AMENDMENT TO AGREEMENT

Project: Marshall Aquatic Center – Phase 1**Stockwell Project No.:** 21045

Amendment No. 3**Attachments:** Rendering of revised design & jet video.

PROPOSED UPGRADED SPLASH PAD

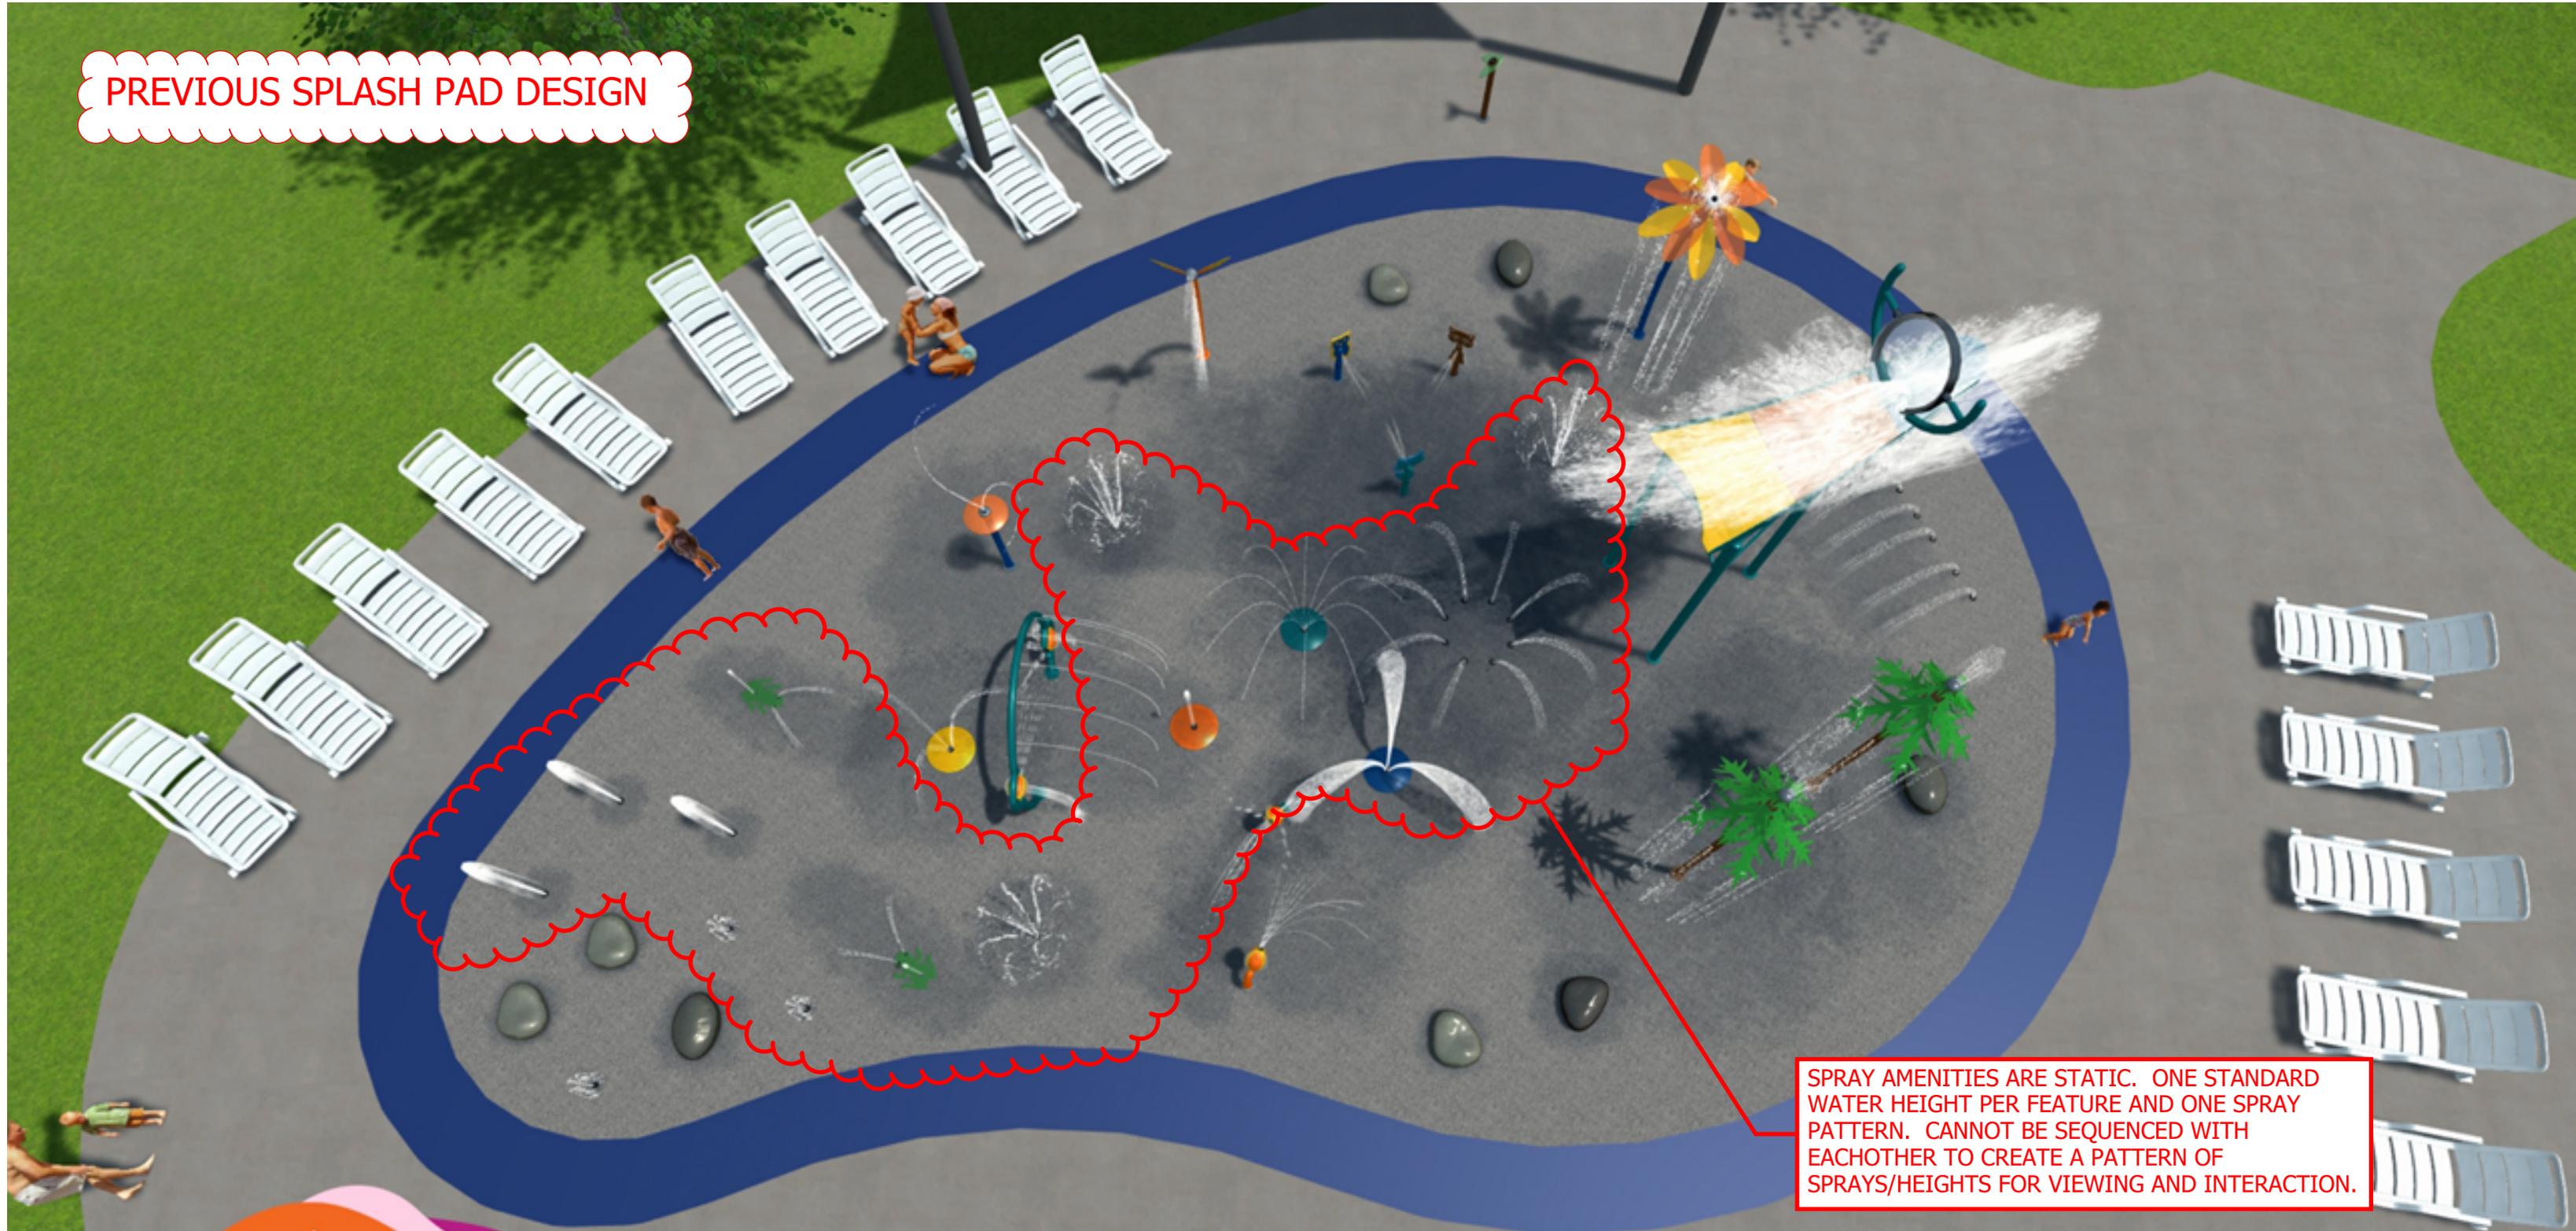
Scope of Services: Client hereby agrees to retain Engineer to perform the following Services to create a more dynamic Splash Pad with control sequences for certain jets and other splash play features per direction from donor and Owner after 60% design submittal approval. Jet sequences would create a timed and sequenced pattern throughout the splash pad of variable ground spray heights that give the appearance of moving water throughout the splash pad, similar to destination plaza fountains. Work necessary to complete the design involves adding additional control panels, additional valves, additional valve vault, and redesign of splash pad spray features and patterns to provide space for the variable water jets.

ADDED VARIABLE HEIGHT SEQUENCED SPRAY JETS. LIGHTS NOT INCLUDED AND ARE SHOWN FOR CLARITY PURPOSES.

SPRAY AMENITIES ARE STATIC. ONE STANDARD WATER HEIGHT PER FEATURE AND ONE SPRAY PATTERN. CANNOT BE SEQUENCED WITH EACHOTHER TO CREATE A PATTERN OF SPRAYS/HEIGHTS FOR VIEWING AND INTERACTION.
